Response to Public Comments

City of Cincinnati BSB Corridor Concept I-W and Cincinnati USA Regional Chamber Footprint Minimization

TO: KYTC and ODOT
FROM: HNTB Corporation
DATE: November 2, 2022
RE: Brent Spence Bridge Corridor Project | ODOT PID 89068 | KYTC Project Item No. 6-17

I-75 Exit Ramp Modifications

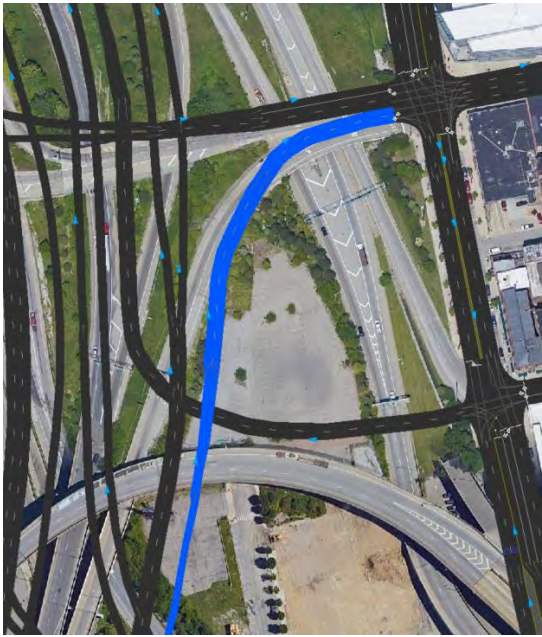
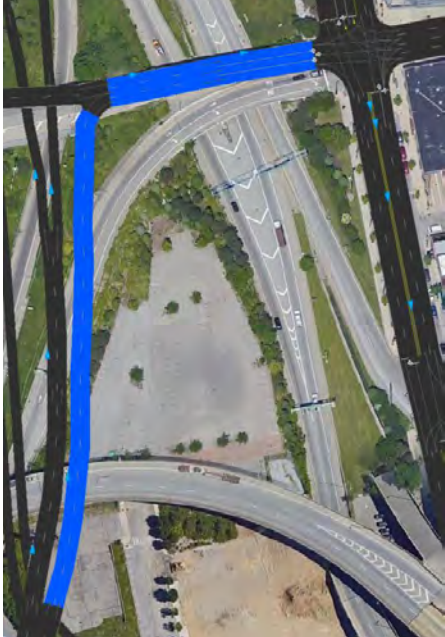
The SB I-75 exit onto 5th St was removed from the Concept I-W design. US 50 and the NB Exit to 5th Street was modified to form a signalized intersection west of Central Avenue. This signalized intersection operates at LOS B or better for both peak hours. The eastbound approach of the 5th Street and Central Avenue intersection is reduced from 4 lanes to 3 lanes. This intersection maintains acceptable operations of LOS B or better.

To accommodate the displaced exiting traffic to 5th Street, a second lane was added to the 7th Street exit ramp. This design change is different from the single lane in Concept I-W but consistent with the existing conditions. The LOS for the SB I-75 CD road before the 7th Street exit ramp changed from LOS B to LOS C during the AM period and remained at an LOS A for the PM period. The volume entering the ramp increased from 3410 vehicles to 6384 vehicles over the course of the 5-hour AM period and 1763 vehicles to 3431 vehicles for the 6-hour PM period. The LOS at the 7th Street and Central Avenue intersection remained at a LOS B for the AM and PM period for this design change.

On the SB I-75 CD road upstream of the 7th Street exit, the road diverges to either 7th Street or continues to 2nd Street, 3rd Street, and Brent Spence Bridge. It was also this section of road where the I-75 exit ramp to 5th Street was located. With the removal of the ramp, a lane was removed from the CD road. The traffic continuing south after the diverge now has three lanes that tapers to two, this tapering distance was shortened to match the distance used in the Concept I design. The LOS for this section changed from LOS B to LOS C during the AM period and remained at a LOS B for the PM period.

Northbound Entrance Ramp Modifications

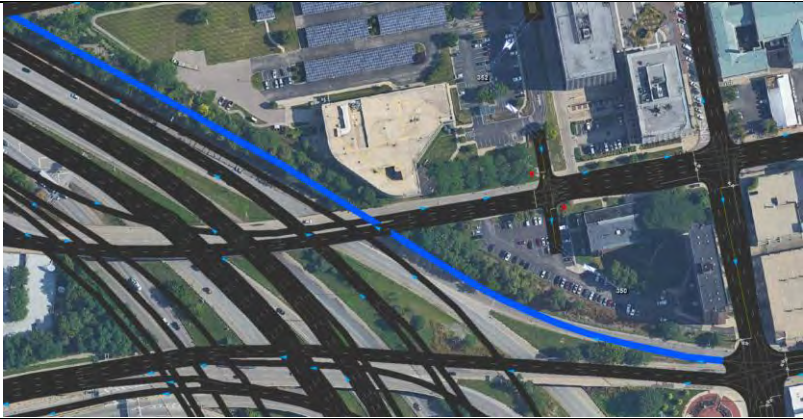
The NB I-75 entrance ramp from 4th Street to the NB CD was removed. The entrance ramp from 3rd Street was modified to include an additional ramp leading to I-75 N to accommodate the displaced northbound traffic. This alteration increased the 3rd Street ramp volume from 829 vehicles to 2553 vehicles over the course of the AM period and 5424 vehicles to 9565 vehicles for the PM period.

The 6th Street entrance ramp no longer goes to the Winchell CD, instead it merges with the NB CD onto I-75 N. The traffic using the 6th St entrance increased from 784 vehicles to 1076 vehicles over the course of the AM period and 1327 vehicles to 1820 vehicles for the PM period. The LOS at the 6th Street and Central Avenue intersection changed from LOS A to LOS B for both the AM and PM period.
